**FIRST AMENDMENT TO
DECLARATION OF COVENANTS, CONDITIONS AND RESTRICTIONS
FOR HEARTWOOD PRESERVE
OMAHA, DOUGLAS COUNTY, NEBRASKA**

NEW WEST FARM HOLDINGS, LLC, a Nebraska limited liability company, and **SOUTH FARM, LLC**, a Nebraska limited liability company (collectively “Declarant”) hereby execute this **FIRST AMENDMENT TO DECLARATION OF COVENANTS, CONDITIONS AND RESTRICTIONS** (this “First Amendment”) as of the date set forth below.

6. ADDITIONAL ELEMENTS

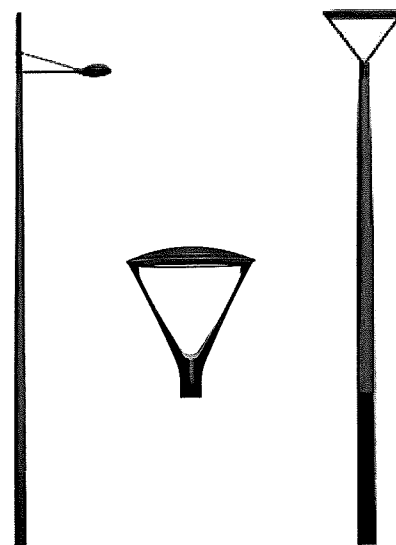
5. Lighting Design Guidelines. Page 60 of the “West Farm/South Farm Design Guidelines,” attached to the Declaration as Exhibit C, is hereby deleted and replaced with a new page and new Appendices thereto, as set forth in Schedule 2, attached hereto.

LIGHTING

- » All exterior and parking garage luminaires shall have black finish and utilize LED light sources with a correlated color temperate of 3,000 Kelvin and a minimum color rendering index of 70

- » Pole-mounted lighting shall be from the approved luminaire and pole configurations shown in Appendix 1 or Appendix 2. All other exterior luminaires (including building-mounted, bollards, floodlights and parking garage lighting) shall be submitted to the ACC for approval

- » Design light levels for parking lots and outdoor automotive sales shall comply with the requirements in Appendix 3. Other areas should comply with the standards and recommendations of the Illuminating Engineering Society (i.e. IES RP-8 for Roadway Lighting)

- » Directed lighting should illuminate the building façade, signs, architectural elements, storefront displays, sidewalks and entrances to enhance visual interest, security, and the comfort of pedestrians at night

- » Light pollution and trespass shall comply with the Omaha Electrical Code – Chapter 44, Article 5, Division 5. In residential areas light should be directed away from windows

- » Lights shall be automatically controlled based on astronomical time-clock or photocell input. Twist lock photocells may be utilized if they have matching finish to luminaire. Outdoor automotive sales lighting shall automatically dim after 8:00 PM Central to approved parking lot lighting levels
